State of Ohio Environmental Protection Agency

September 1, 2004

Re: Belmont County
American Energy Corp., Century Mine
OIL00091*GD
NPDES Modification
Correspondence (IWW)

We have received your NPDES permit modification for the addition of process discharges from ponds 20 and 21. Additional information is required before processing can continue.

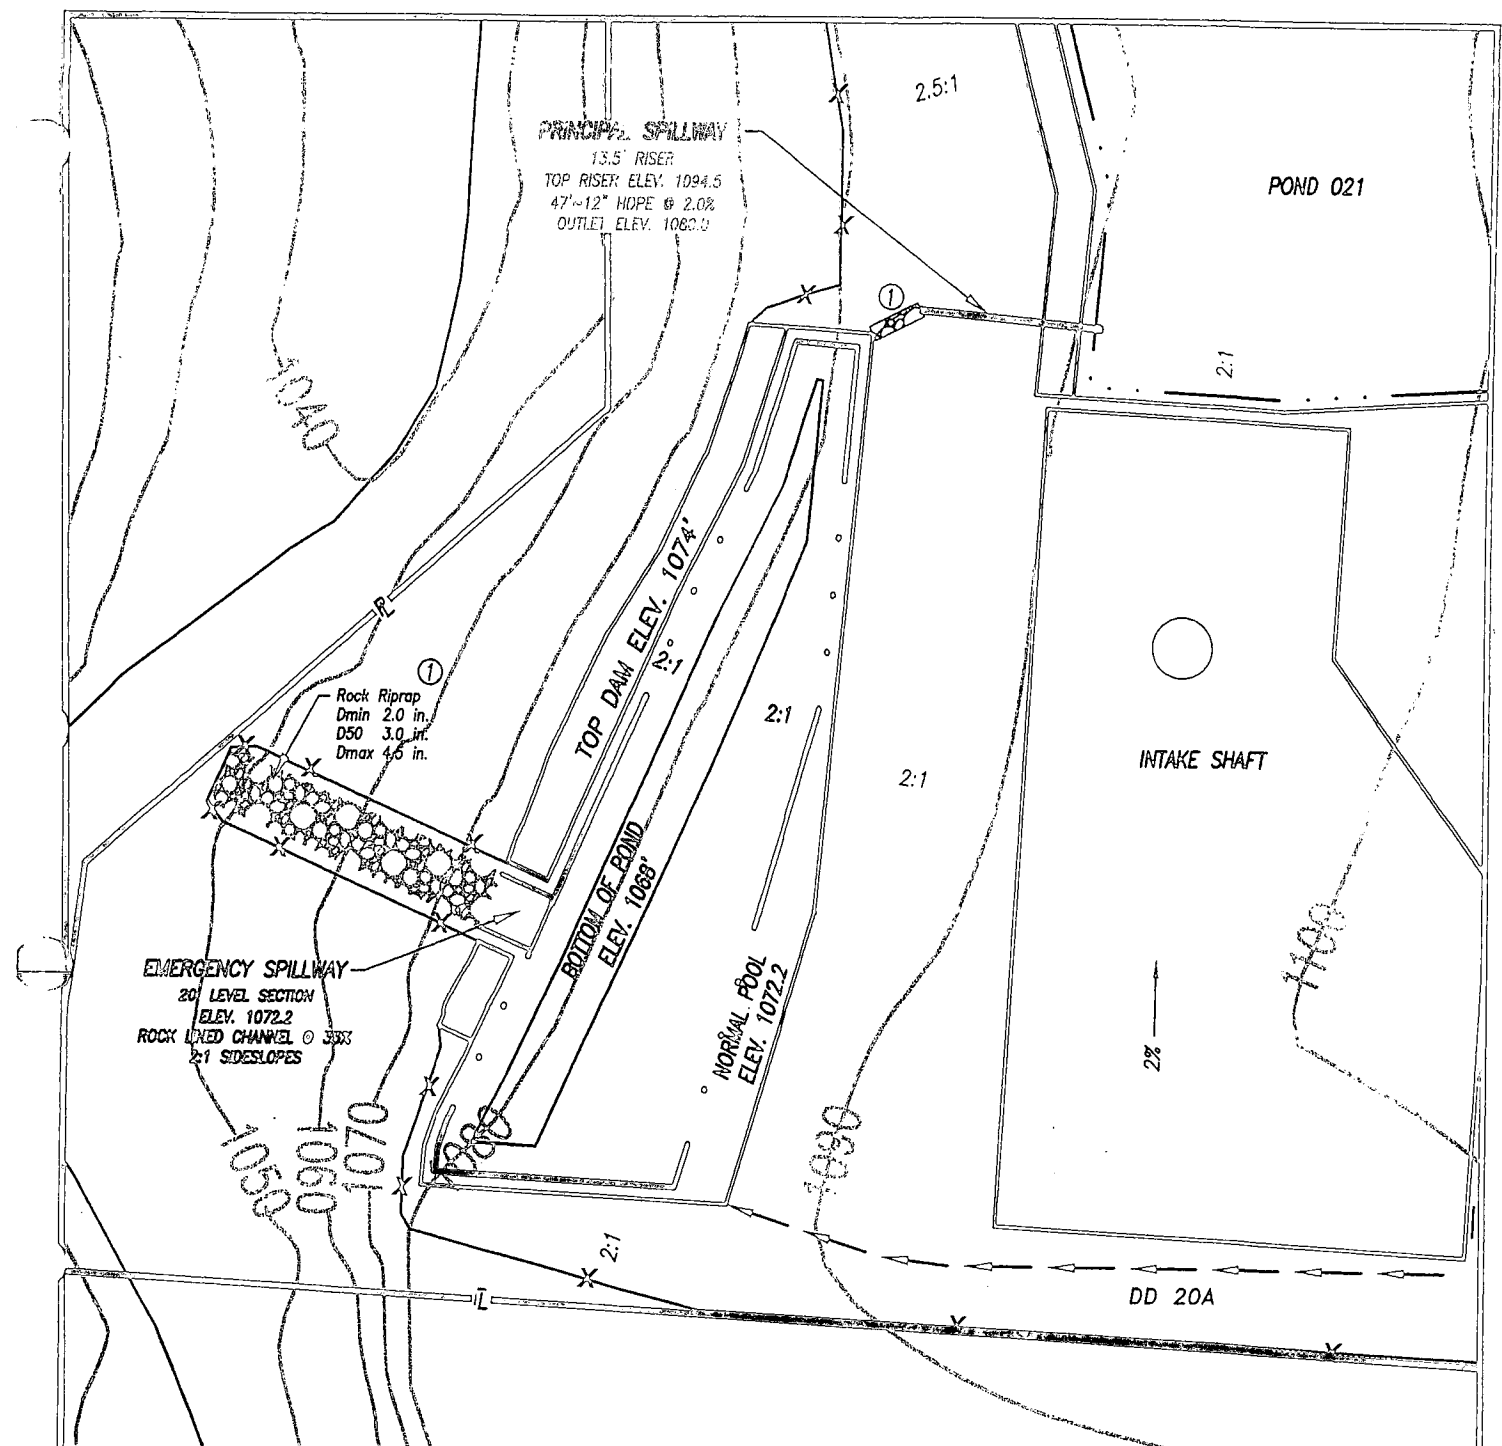
1. Since the ponds were built under the Coal General Permit, a Permit to Install (PTI) application is not required, however, copies of the pond designs are required.

1. Copies of the pond designs are attached.
2. A fee check for \$200.00 made payable to "Treasurer, State of Ohio" is attached.
3. Provided the requested information. See revised response to the Application for Modification of Ohio NPDES Permit, Item 7., as well as the revised responses to items C.4.d. and C.4.e. in Attachment 1 to the Antidegradation Addendum, pages 2 and 3.
4. See revised response to the Application for Modification of Ohio NPDES Permit, Item 7., as well as the revised response to item C.4.d. in Attachment 1 to the Antidegradation Addendum, page 2.
